| | TITLE: M50XLD STANDARD MIXER | | |
| | PREVIOUS DWG. #: _____ | DWG. #: M11400 | REV: - |
| NOTE: | WITH P-5 POWDER FEEDER, LOW SAND, NO LEAK SLIDE GATE | | PG. #: 1 OF 1 |

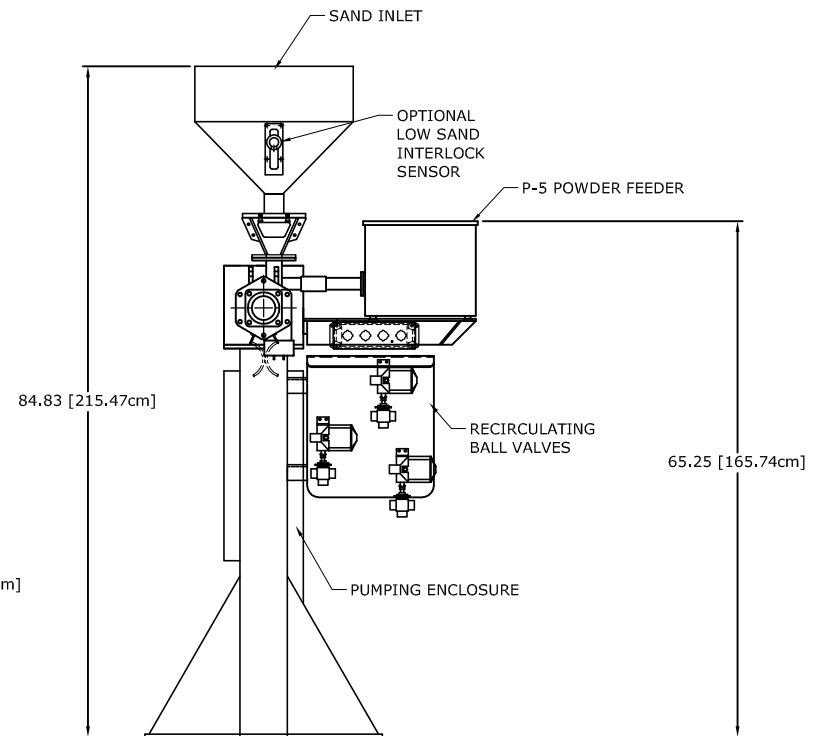
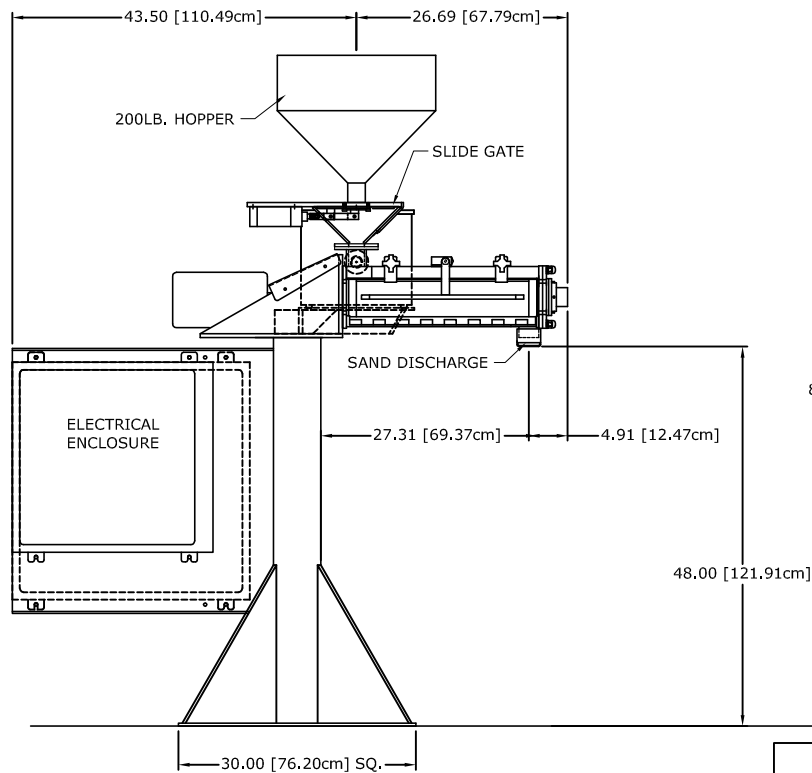
- POWDER AUGER SIZING QUESTIONS**
- 1-WHAT TYPE OF POWDER ADDITIVE IS BEING USED?
 - 2-WHAT %AGE OF ADDITIVE BASED ON SAND WILL BE ADDED?
 - 3-WHAT IS THE BULK DENSITY OF THE ADDITIVE?
